**Advisory Action  
Before the Filing of an Appeal Brief**

10/666,082

ITO ET AL.

**FIG. 1**

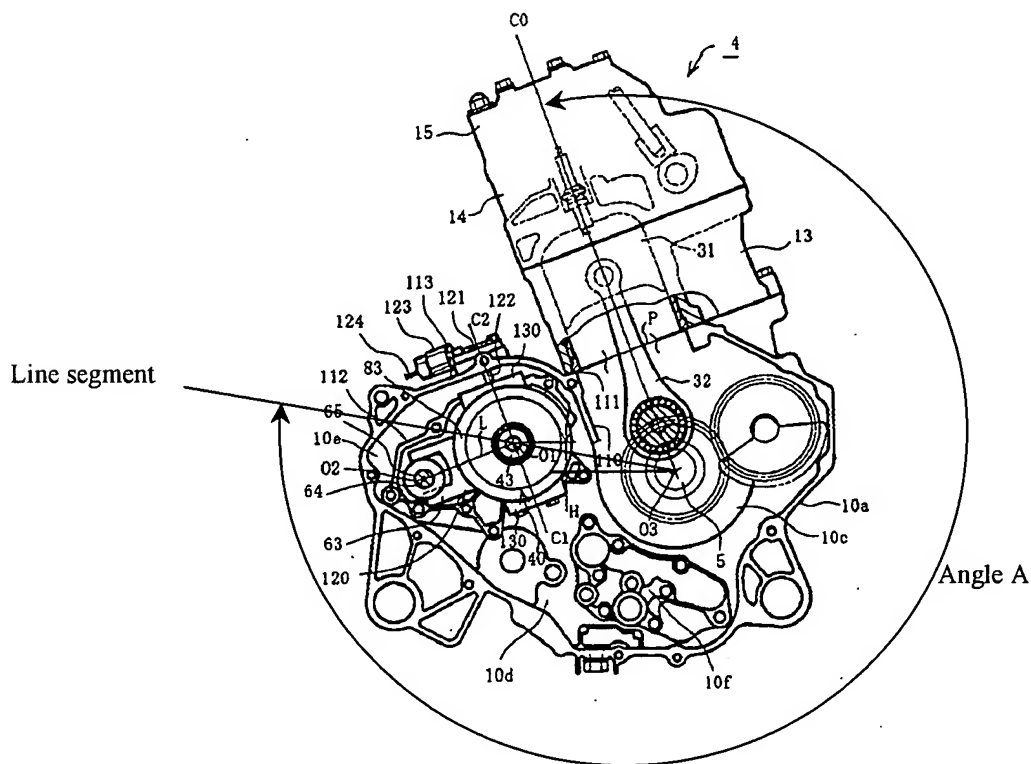
Regarding Applicant's arguments on page 5, paragraphs 4 and 5, note that, in Ito et al., the axis 02 of the shaft 64 is inside of the angle A (see below) defined by a line segment passing through the axis 01 and the axis 03, and the axial line CO.
